# CITY OF ALBUQUERQUE

**RE: Carlisle Marketplace  
2100 Carlisle NE  
Conceptual Grading Plan Stamp Date: 8/21/19  
Drainage Report Stamp Date: (8/28/19)  
Hydrology File: H17D097**

Based on the submittal received on 8/21/19, the Conceptual Grading and Drainage Plan cannot be approved until the following are corrected:

| REVISION                                                                                               |                      |         |           |
|--------------------------------------------------------------------------------------------------------|----------------------|---------|-----------|
| SHEET TITLE:                                                                                           | CONCEPTUAL GRADING   |         |           |

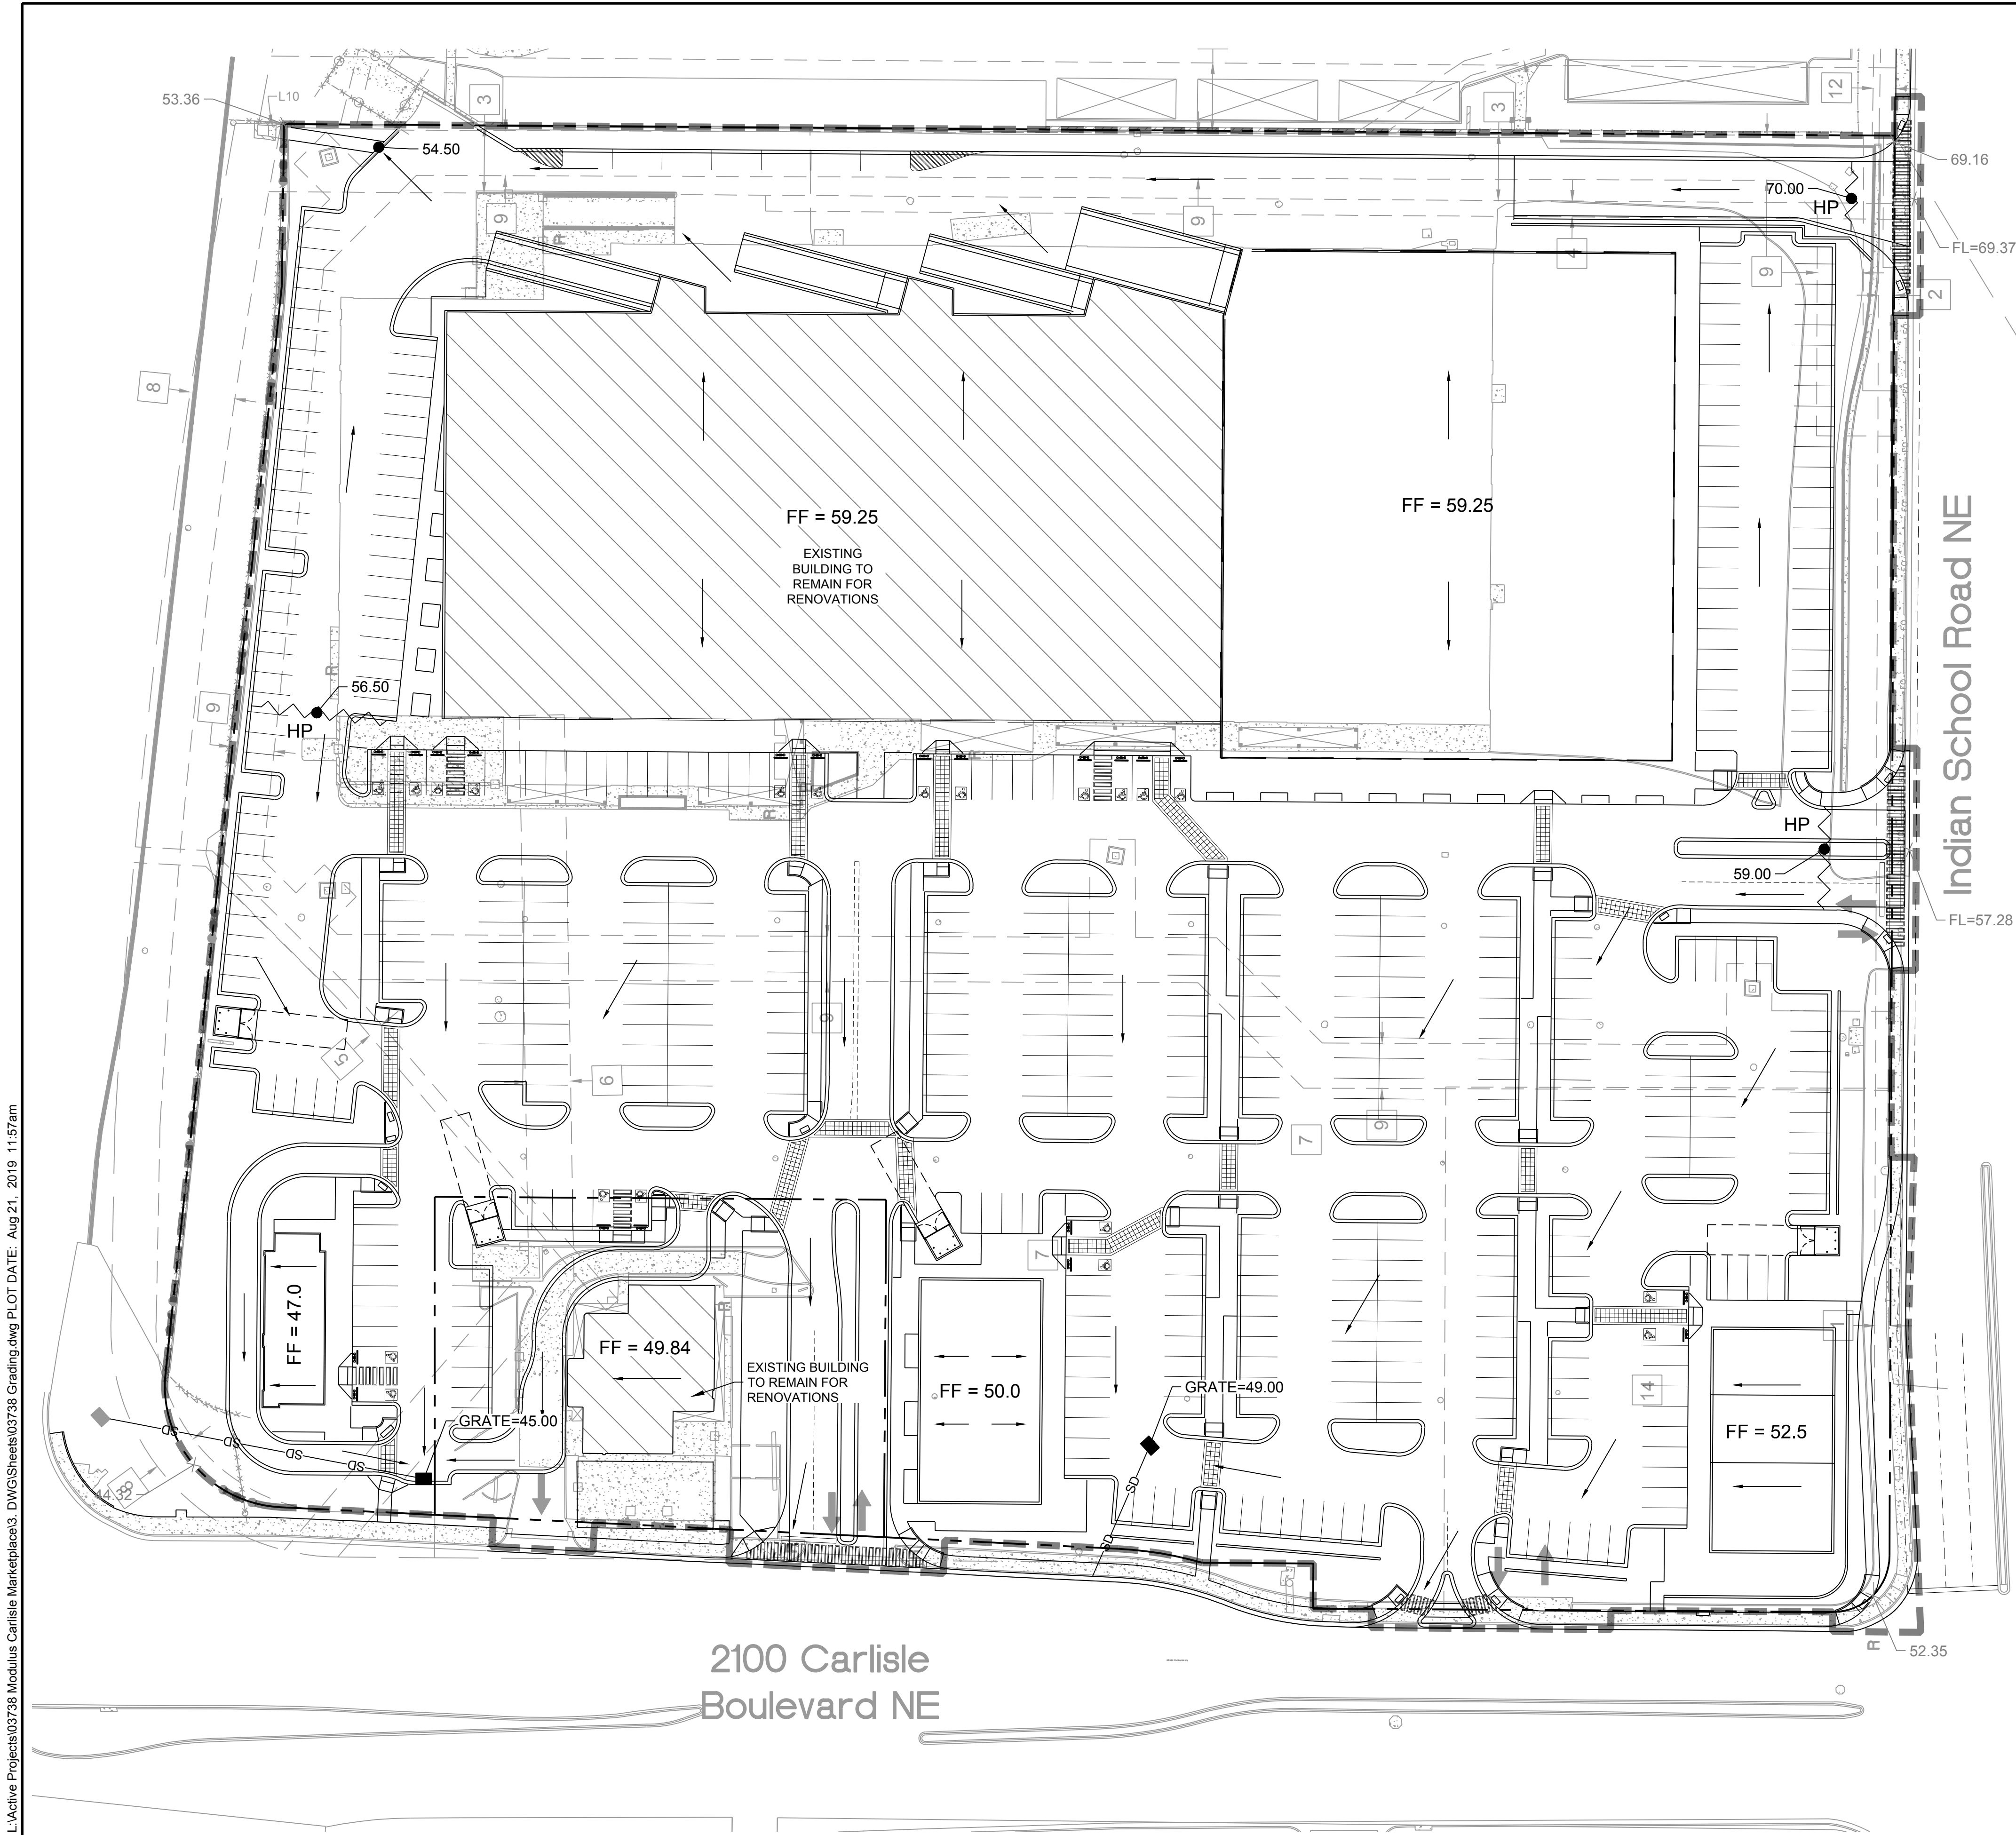
1. Show the grading and site work on the grading plan per the DPM Ch.22.7, *Grading Plan Checklist*; the following items are missing/deficient:
  - a. Existing contours
  - b. Proposed contours
  - c. Spot elevations adequately showing conditions on-site.
  - d. Contours and spot elevations extending a minimum of 25' beyond property line.
  - e. Ponds
  - f. Elevations along property lines
  - g. Phasing (if phased)

5. Please show and label the pond(s) and include a label on each with the SWQV and elevation, the 100-year volume and elevation, the peak 100 year inflow and outflow, the spillway crest elevation, and the spillway flow depth.
6. Additional comments should be expected, based on the outcome of the above remarks and level of detail shown on plans.
